#### Summary/Reason Statement for DRH14-00006

Project: New Sockeye Sales Office / Wholesale Building

## **Planning Division Staff Report**

File Number DRH14-00006

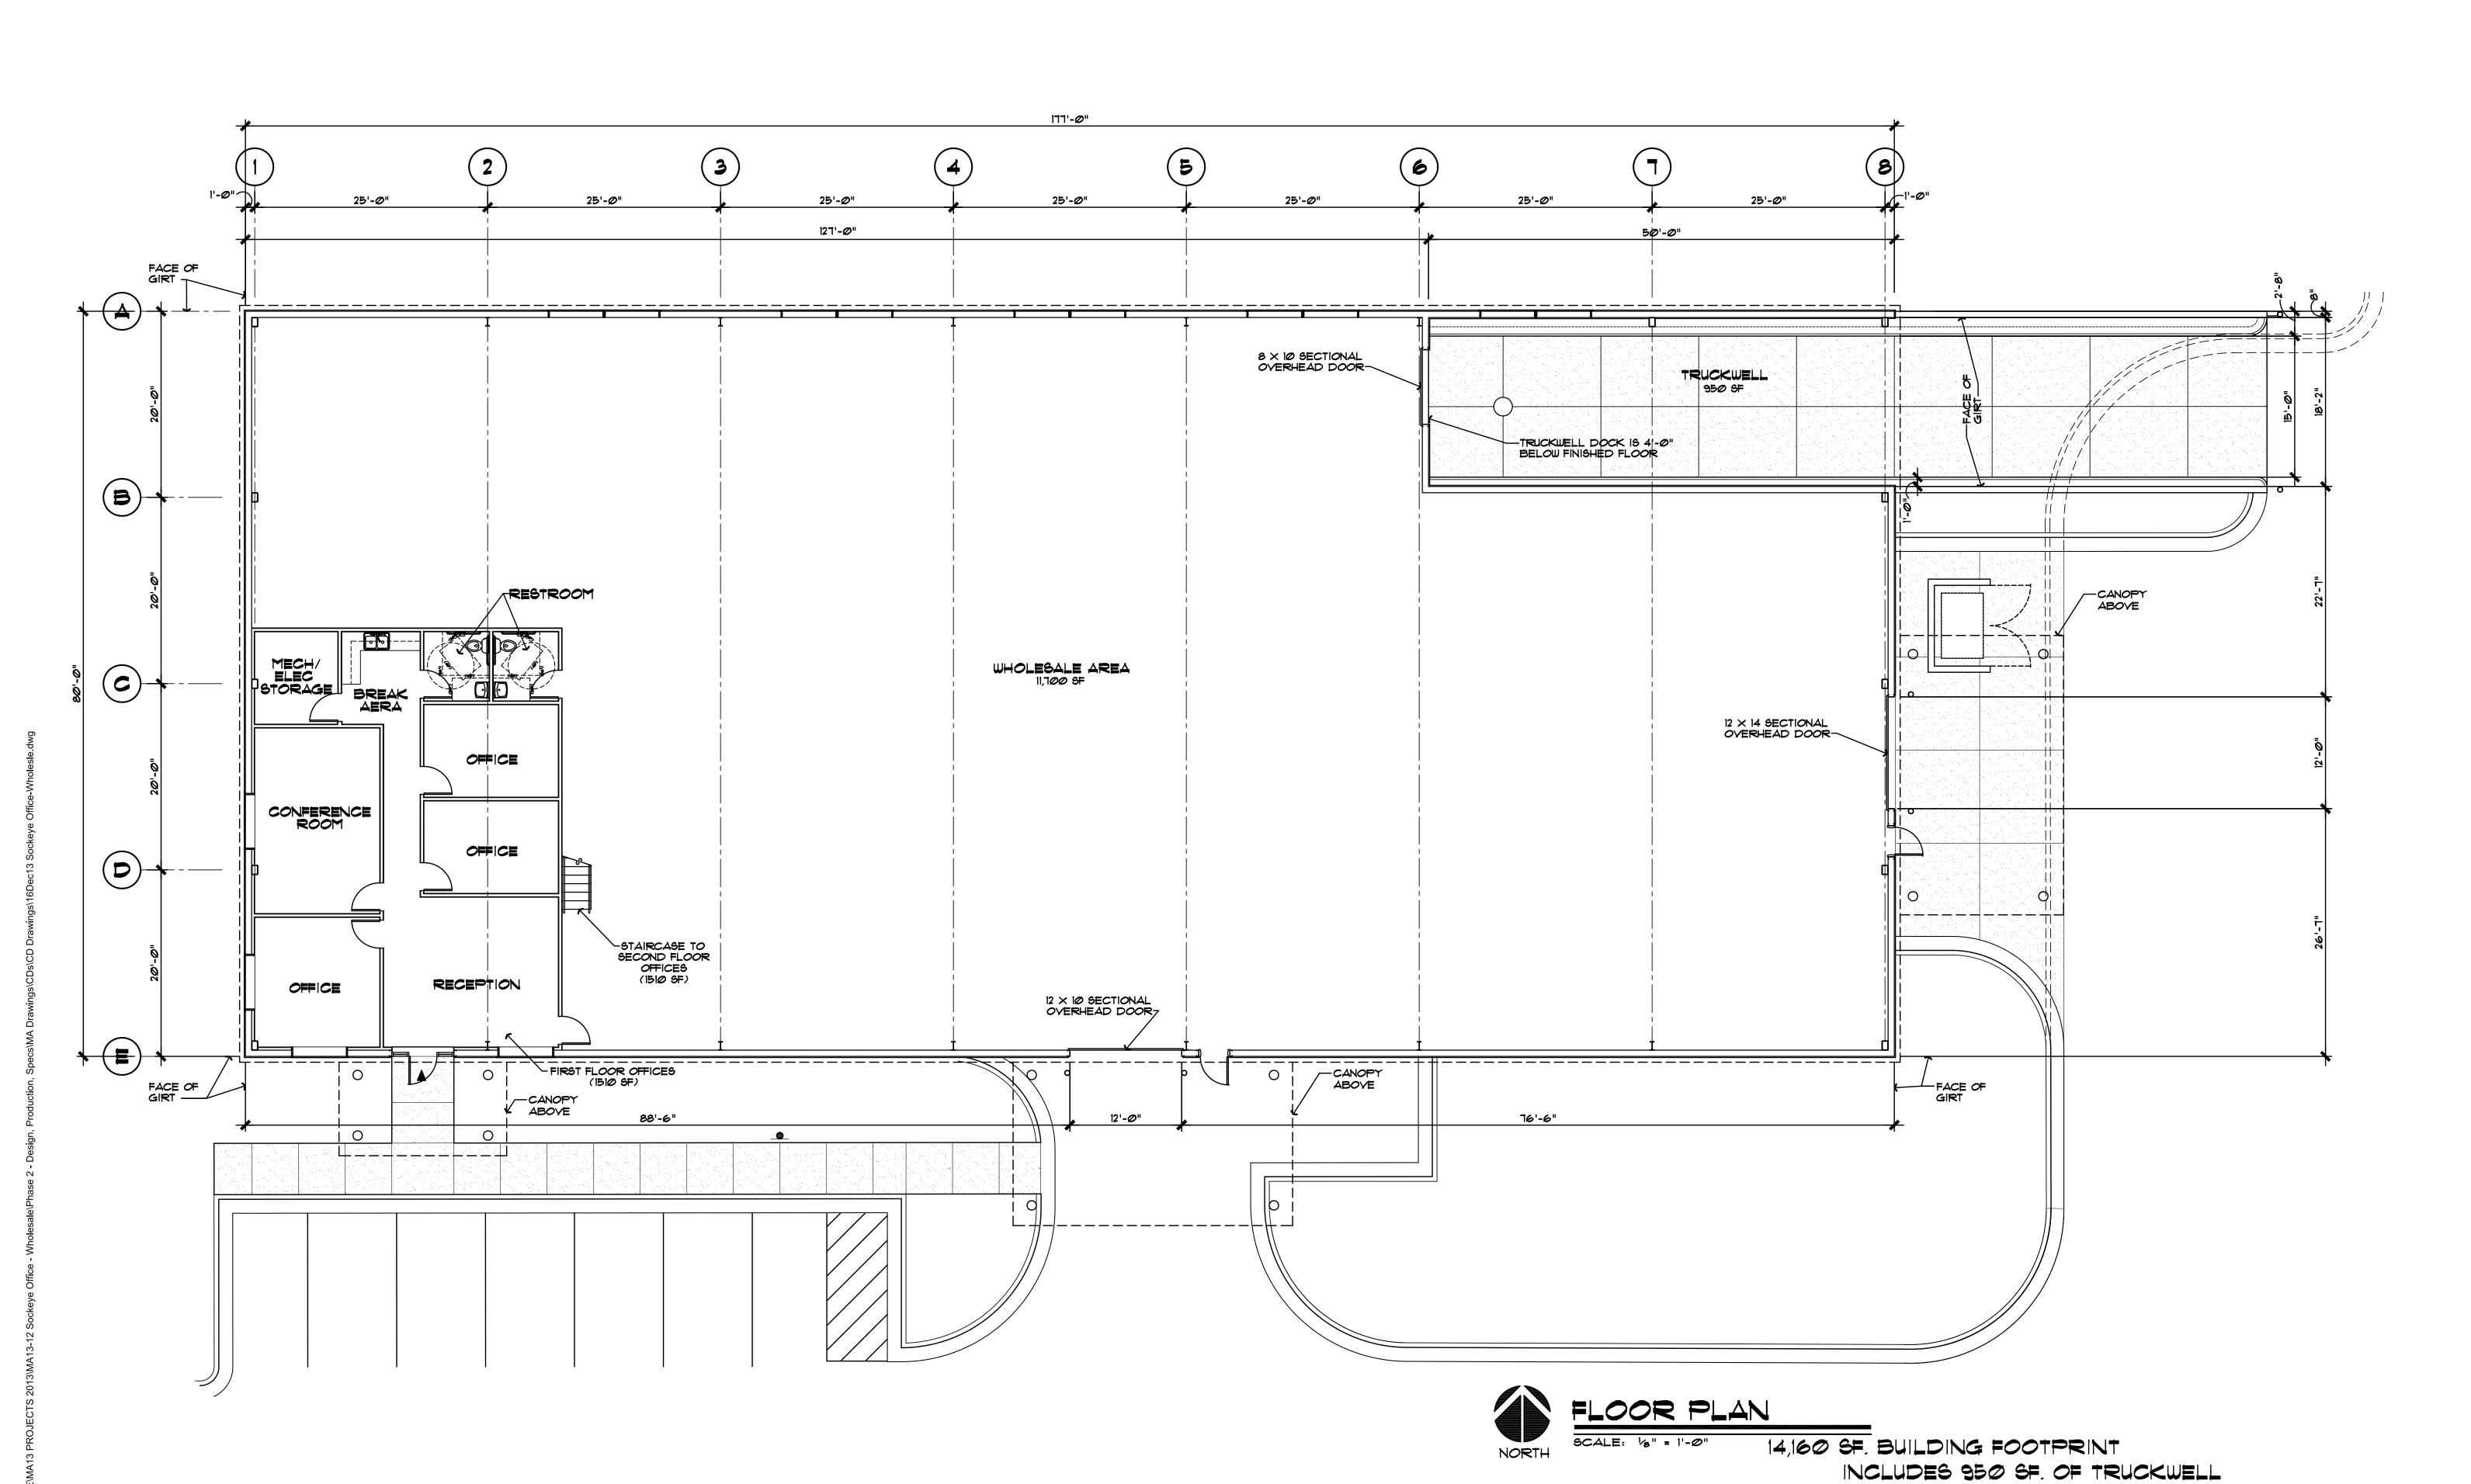
Landscape planters along the front of the building will be planted with shrubs and ornamental grasses. The rendering of the building elevations submitted with the application shows small trees along the front of the building between the office and the overhead door; however the planting plan does not. The landscape plan should be revised to include plant materials at least six feet in height at this location to help break up the large blank wall plane. A Chanticleer Pear should be added to the planter at the east end of the row of parking in front of the building to satisfy ordinance requirements and create symmetry with the Pear tree proposed in the planter to the west. Columnar evergreens shall be added to the west property line and be located adjacent to the portion of the building elevation which does not have windows proposed. The submitted landscape plan contains errors which shall be corrected and resubmitted prior to building permit application. The proposed Compact Burning Bush and Ivory Halo Dogwood shrubs will not attain the size shown on the plan at maturity and should be revised to accurately represent their diameters. There is also an unidentified shrub symbol which shall have an appropriate species designated.

- c. Submit a material for the proposed wainscot on the building and continue at full height around the office portion of the building.
  - d. Revise the landscape plan to show correct sizes for the Compact Burning Bush and Ivory Halo Dogwood plant materials.

- e. Add plant materials at least six feet in height to the planter along the front of the building between the office and the overhead door.
  - f. Assign an appropriate species to the unidentified shrub symbol on the landscape plan.

- g. Add a Chanticleer Pear tree to the planter at the east end of the row of parking in front of the building.
  - h. Add columnar evergreen trees to the landscape buffer on the west property line.

ELEVATIONS

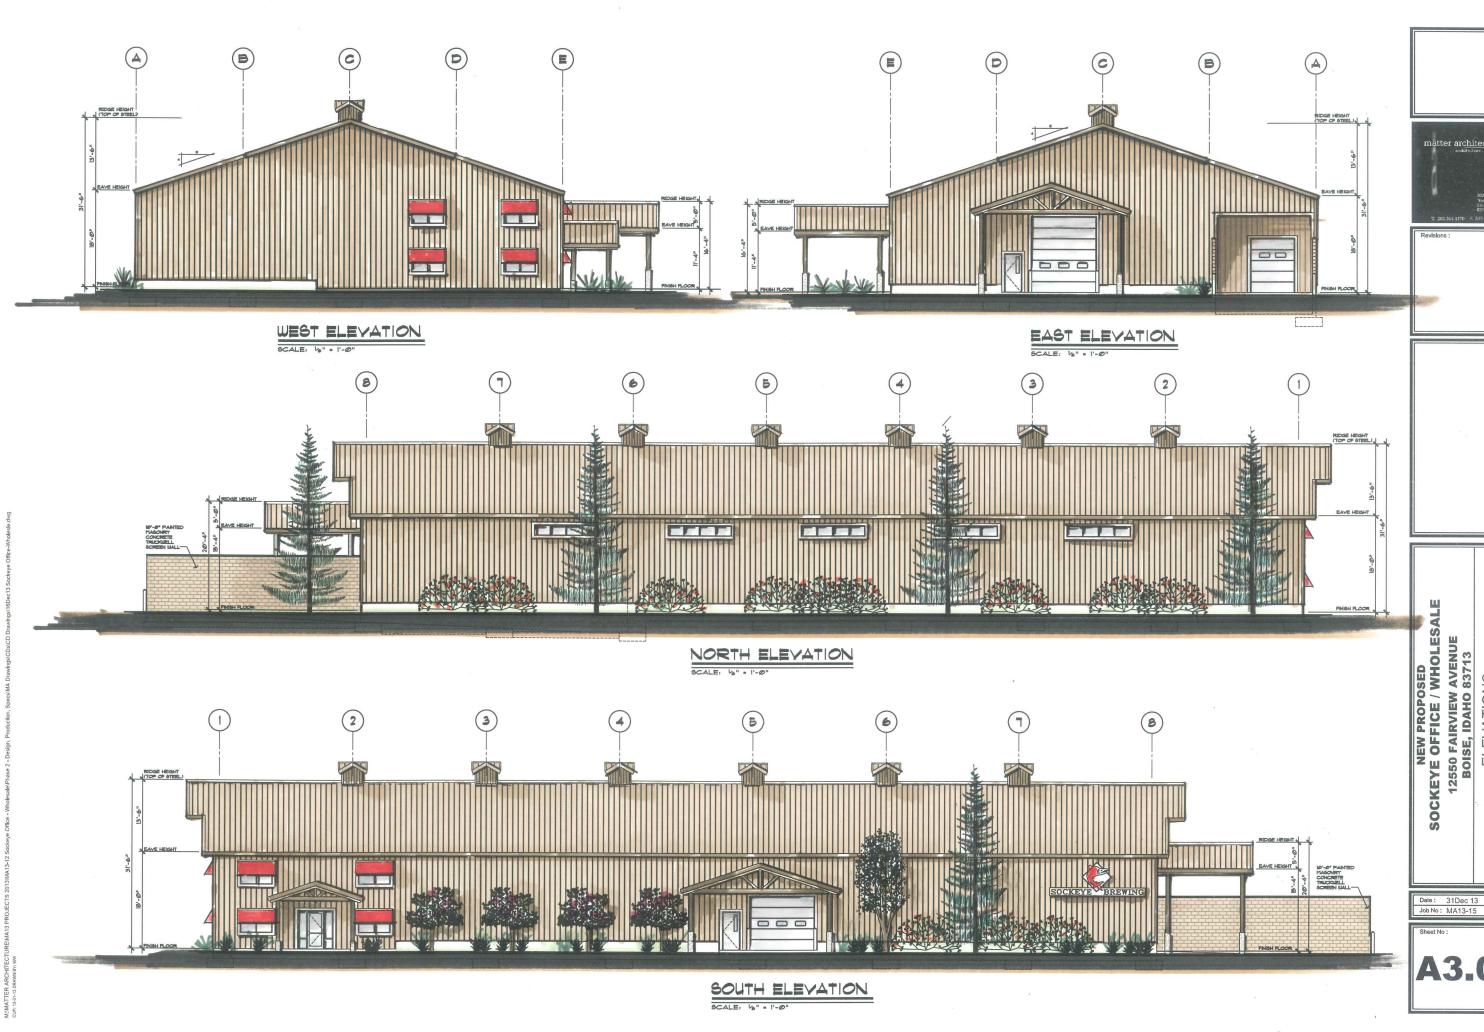
The building uses projecting canopies, sunshades, windows, and variations in form provided by horizontal and vertical design elements to break up the massing and provide design interest. The proposed building uses the same color metal for the walls and roof and should be revised to provide a contrasting roof color to break up the massing and create an impression of reduced mass. The massing, height, and design are typical of the type of building and are compatible with surrounding structures and uses. The building is in scale with other structures within the immediate area and the expansion of the existing use in a new building will not negatively impact the adjacent properties.

The building design uses accent colors, ornamentation, canopies, and window placement to provide design interest. Shadow lines are provided by the projecting canopies at building entrances and sunshades. Windows have been appropriately provided on the office area at the southwest corner of the building. The front elevation should be revised to include four clerestory windows in a size and spacing similar to those proposed on the rear elevation in order to further break up the large wall plane and provide additional detailing, while providing natural light to the warehouse area inside.

- a. Add four clerestory windows to the front elevation of the building in a size and spacing similar to those on the rear.
  - b. The metal roof shall be a contrasting color to the building walls.
